Submittal

Date: April 20, 2015
Project: Shrewsbury STP 1443 (44)

Copies	CCI Submittal Number	Specification Section	Description
Electronic	2r1	652.10	Erosion Prevention and Sediment Control Plan

MODIFICATIONS TO

PHASE I SITE SPECIFIC EROSION CONTROL PLAN
SHREWSBURY STP 1443(44)

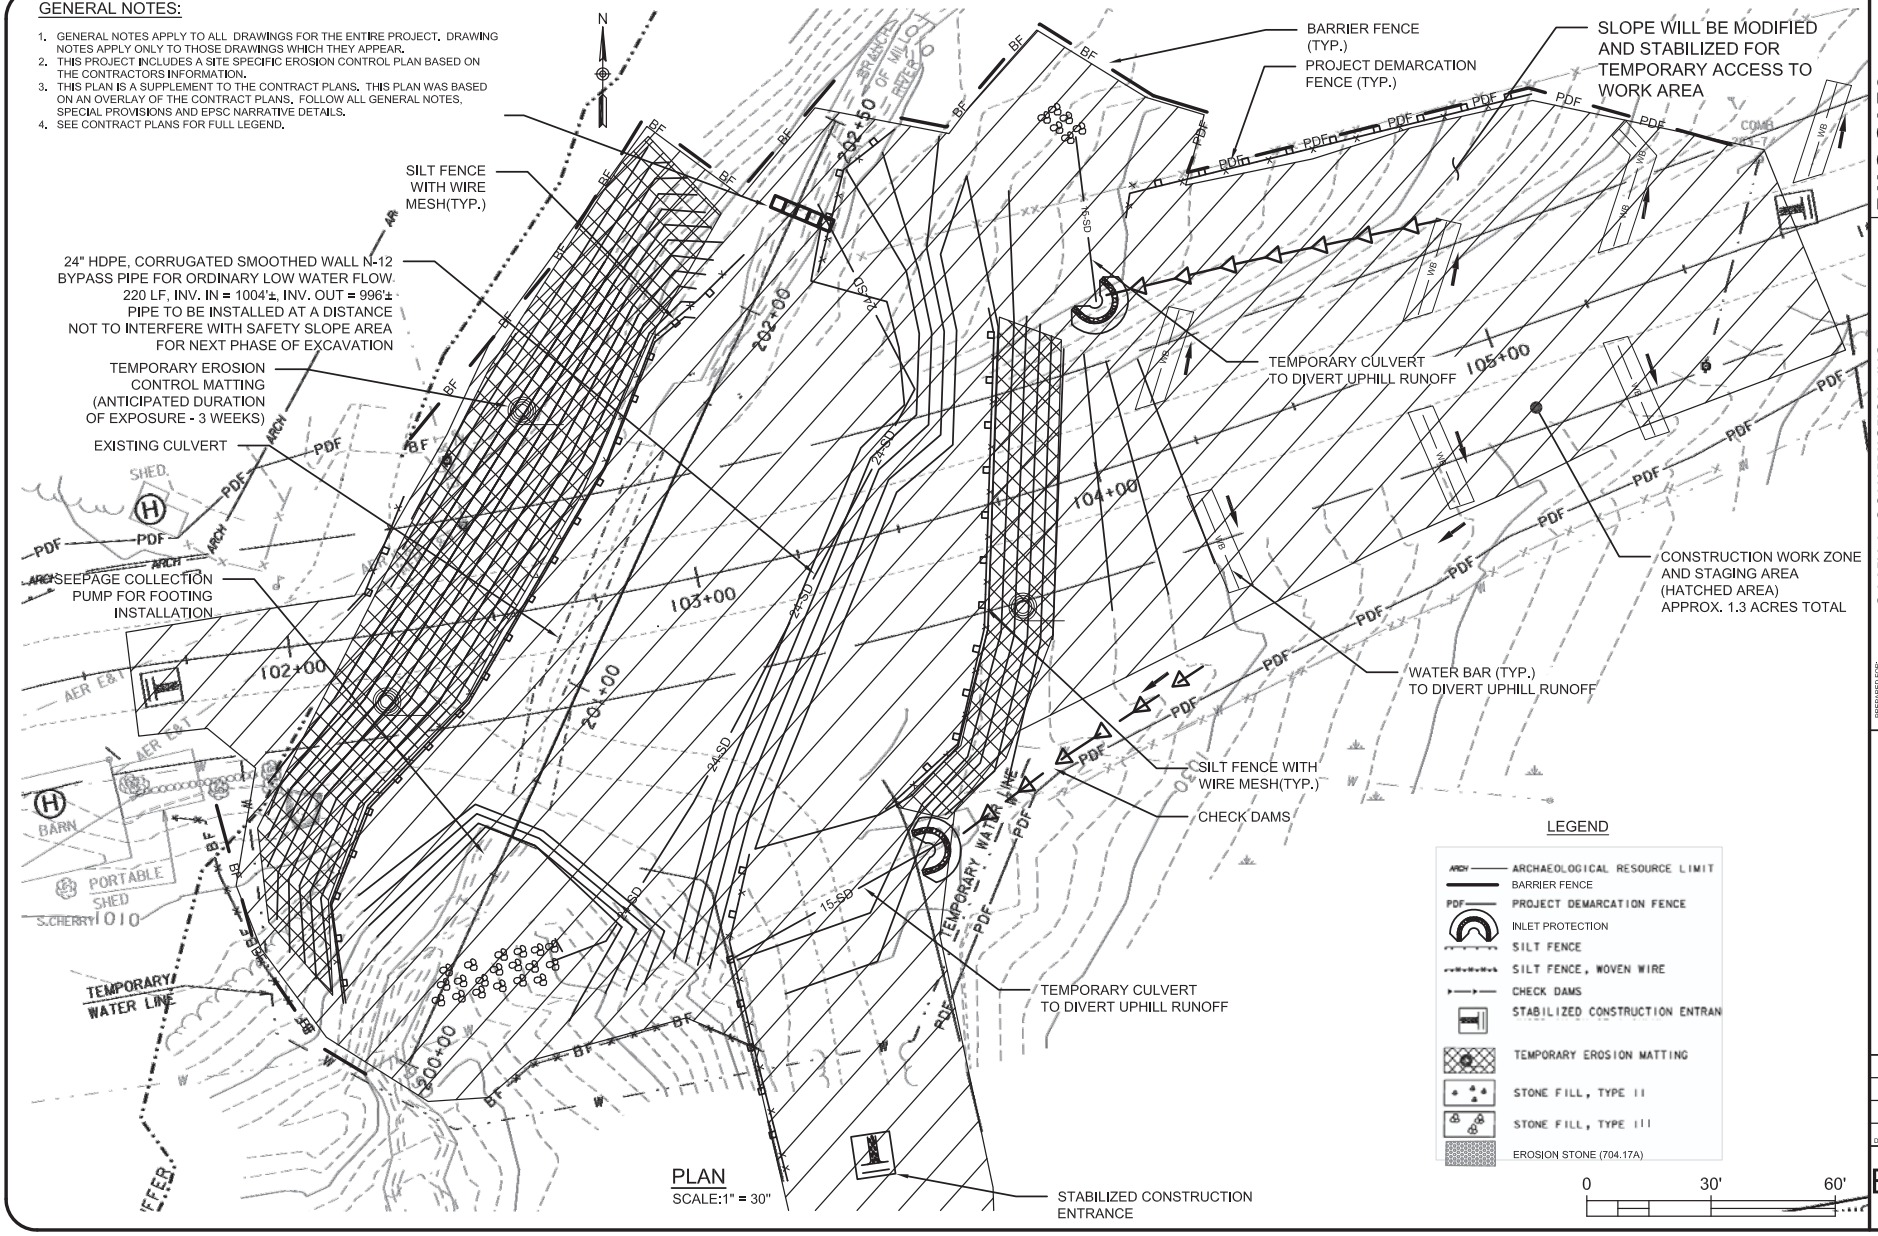
Initial EPSC measures will be installed when the EPSC plan has been approved by the Agency. Project Delineation Fence and Barrier Fence will be installed to identify the limits of disturbance. Trees and brush will be removed from the site. Silt fence and water bars will be installed as grubbing begins. Temporary Stabilized Construction Entrances will be installed at each approach to the project after the road closure when subgrade excavation begins. These entrances will be of minor significance as excavation during the first couple of days will limit the access to the project. The significant stabilized entrances will be on the old Route 103. Silt Fence with wire mesh, temporary culverts, water bars and stone check dams will be installed as shown on the Phase 1 Plan. Excavation slopes in phase 1 will have the longest exposure during the 28 day project and will be protected with temporary erosion control fabric. The highest risk for erosion will be from the conveyance of offsite runoff through the work area.

Waste Area

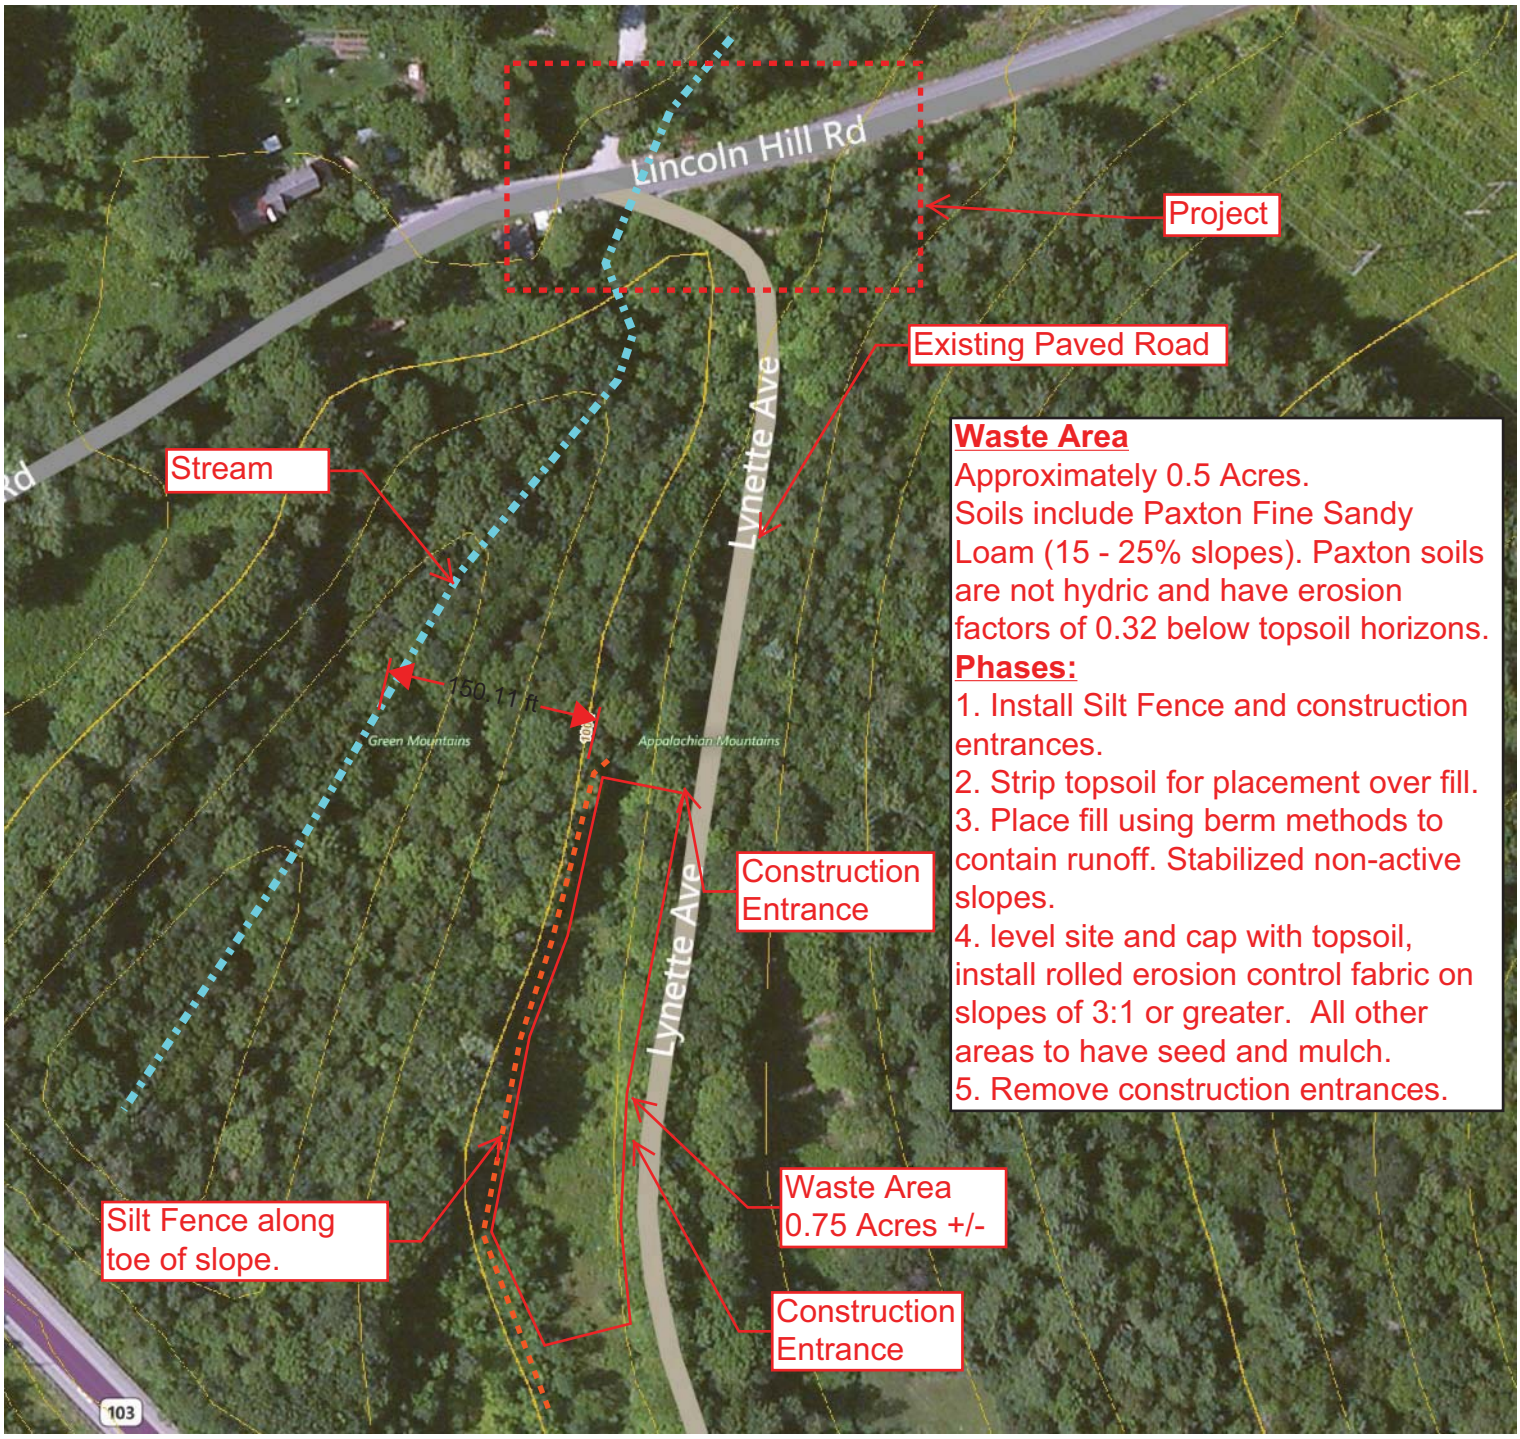
Add. – 1.1.1: The Project will also include a waste and borrow site. Site staging will be within the limits of the work area limits of disturbance. The waste area will be approximately 400 feet south of the project on the old route 103 (now Lynette Ave, T.H. 49). The waste area will be used to dispose of approximately 2000 cubic yards of material.

Offsite activities will also occur on the Fillmore property to the south of the project adjacent to old Route 103 (T.H. 49). An offsite activities form will be completed for the site and work will occur as shown on the waste area site plan. Approximately 2000c.y. will be disposed of at the site.

1. Install Silt Fence and construction entrances.
2. Strip topsoil for placement over fill.
3. Place fill using berm methods to contain runoff. Stabilized non-active slopes.
4. level site and cap with topsoil, install rolled erosion control fabric on slopes of 3:1 or greater. All other areas to have seed and mulch.
5. Remove construction entrances.

PHASE II SITE SPECIFIC EROSION CONTROL PLAN
SHREWSBURY STP 1443(44)

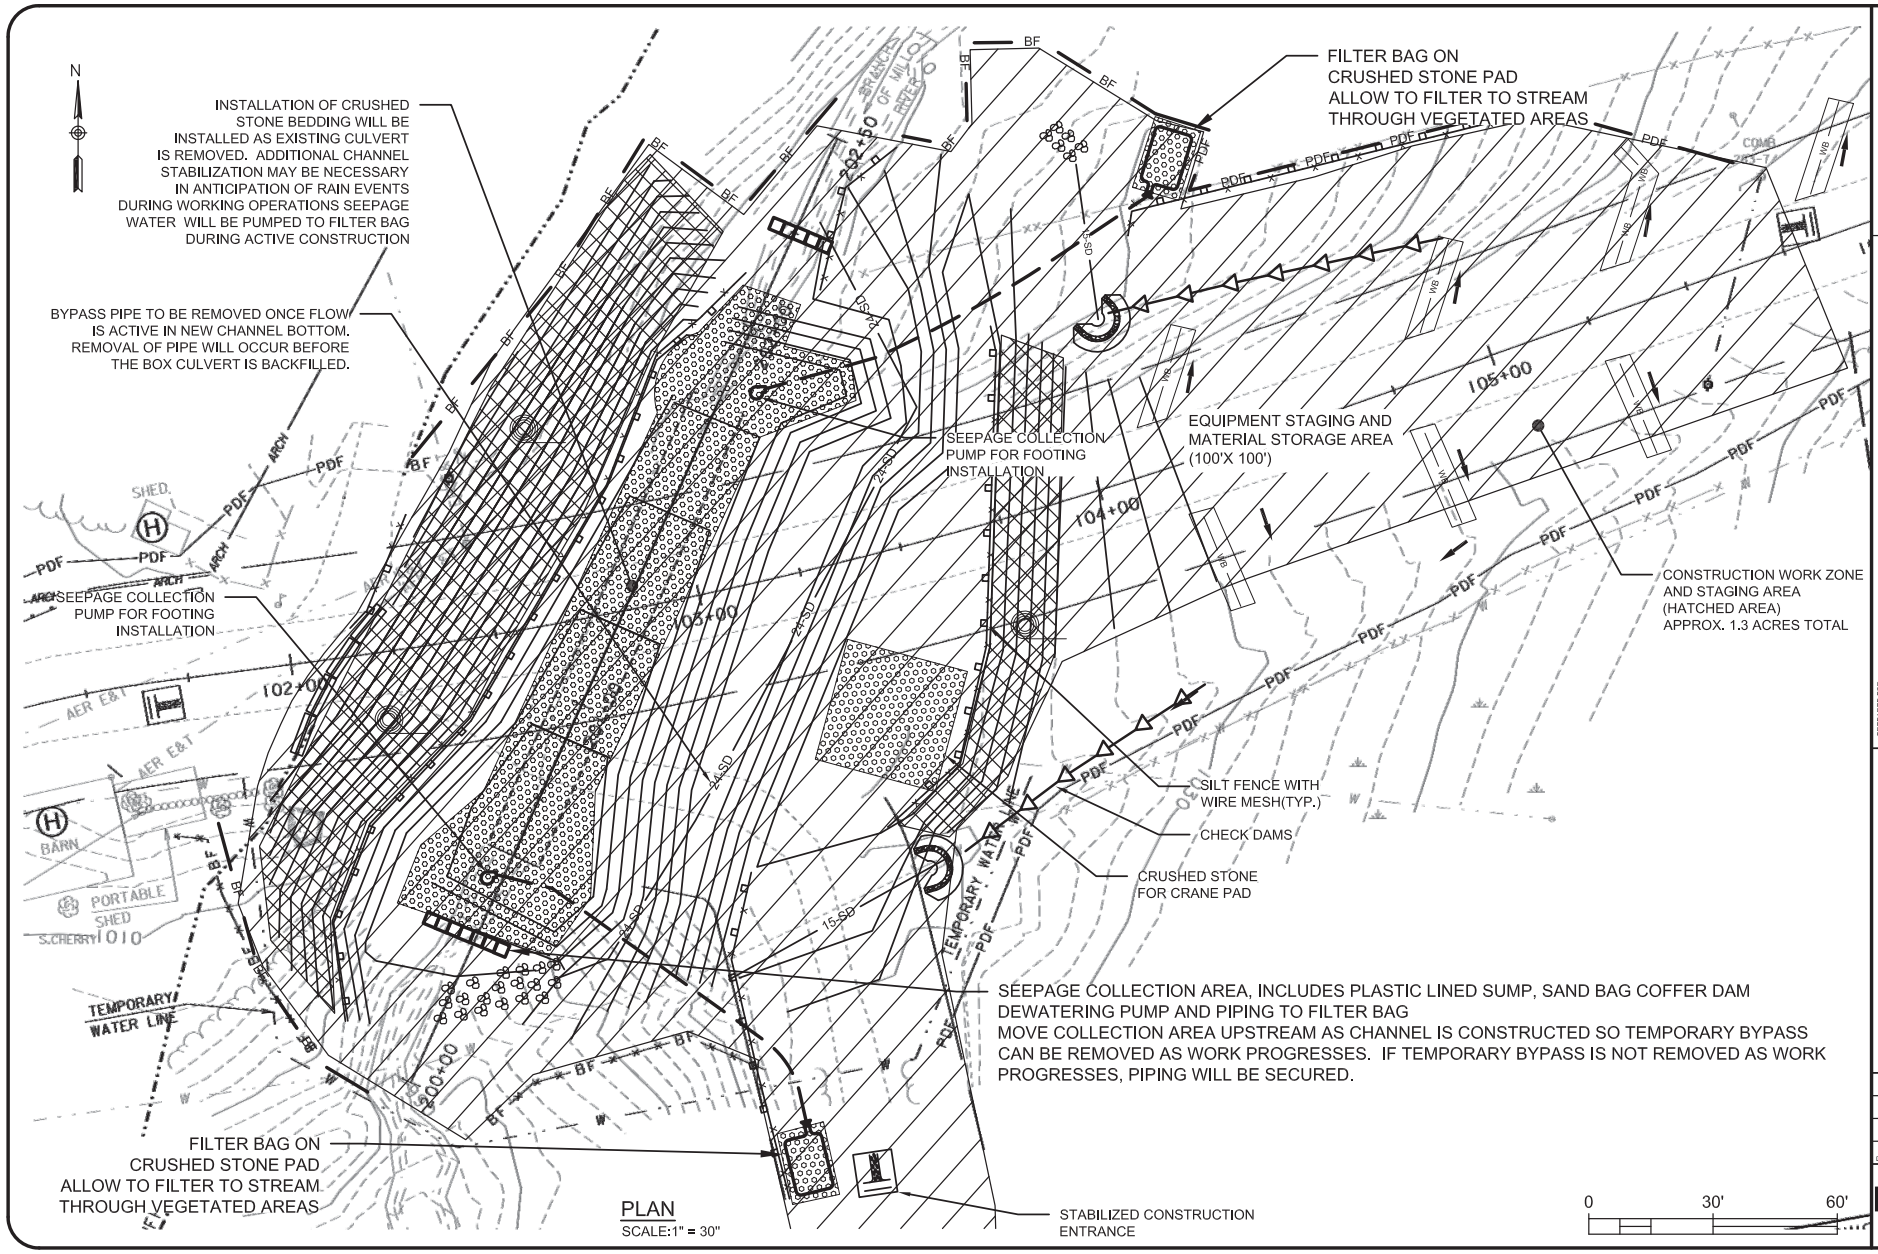
1.5.1.2. Culvert and Channel Excavation (Phase 2)

The existing culvert is approximately 15 feet below grade. Access to remove the culvert and associated fill will be from the southeast on old route 103 and from a construction road along the northeast side of the project. Excavation will begin at the outlet and channel excavation will be completed in sections as the culvert is removed and new stone fill is installed for the footing base.

Prior to beginning final excavation, temporary measures will be used to control stream flow. A temporary 24” culvert will be installed around the work area. The inlet to the culvert will be upstream of the project and will be controlled by a sandbag and plastic dam. The system will be designed to allow overtopping during higher flow events. This will require the work area to be stabilized in advance of a storm. A two year storm event may produce 80 cfs based on the Hydraulics Report. This will require the bottom foot of the work area to be lined in crushed stone to maintain a velocity at approximately 5 feet per second.

During active channel excavation and stone fill installation, seepage is anticipated. The seepage will be collected behind a sand bag coffer dam. A dewatering pump will be used to convey seepage water to a filter bag. The filter bag will be located such that

overland flow is possible prior to discharging back into the Mill River Tributary. See EPSC Plan for location.

PHASE III FINAL EROSION CONTROL PLAN
SHREWSBURY STP 1443(44)

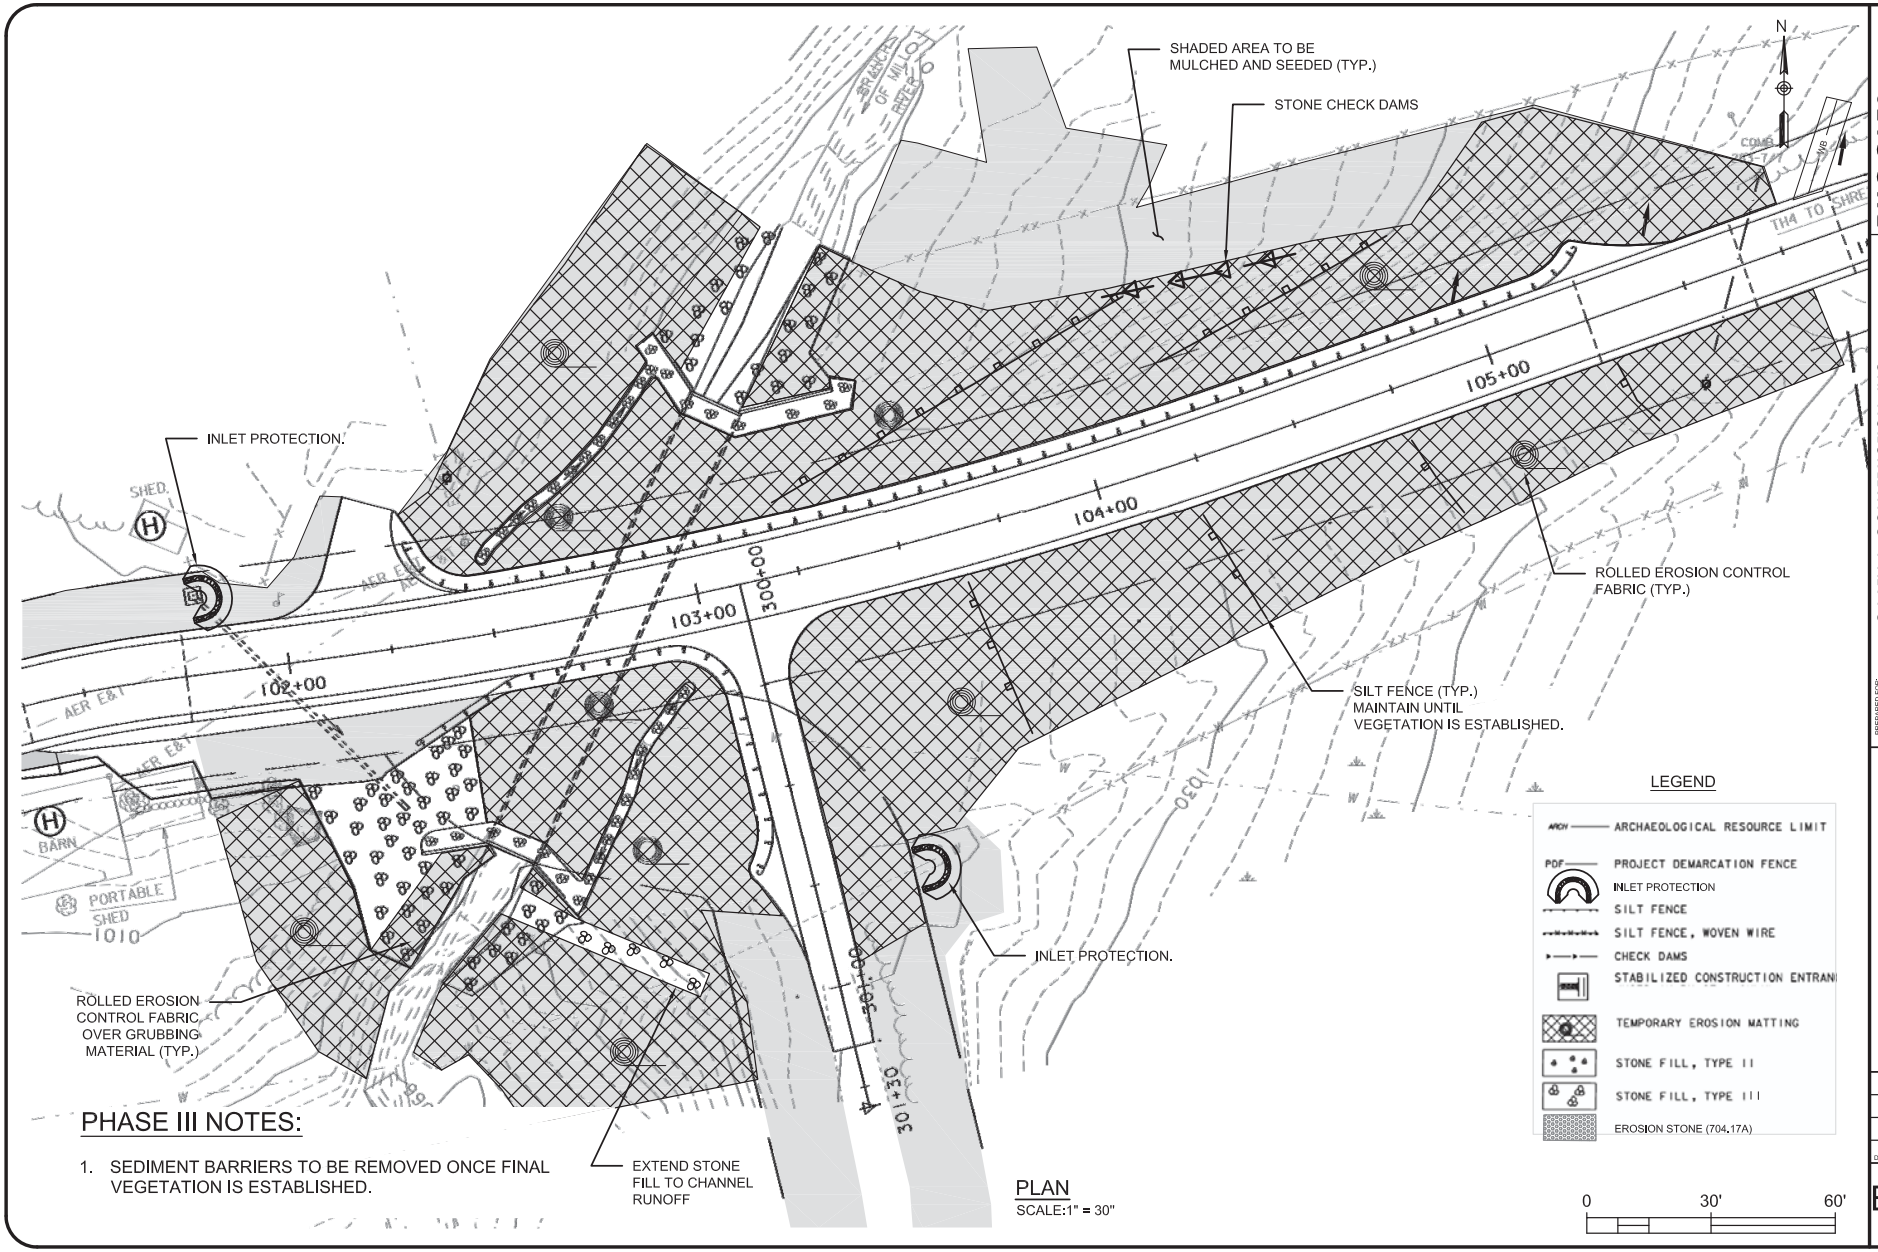
The work area will be restored to final stabilization working away from the culvert work area. The dewatering access and site area will be returned to finish grade and final stabilization measures will be installed, including erosion matting. Silt fence will remain until vegetation has been established on the site. Once the site is stable, all structural measures will be removed and property disposed.

1. SEDIMENT BARRIERS TO BE REMOVED ONCE FINAL VEGETATION IS ESTABLISHED.
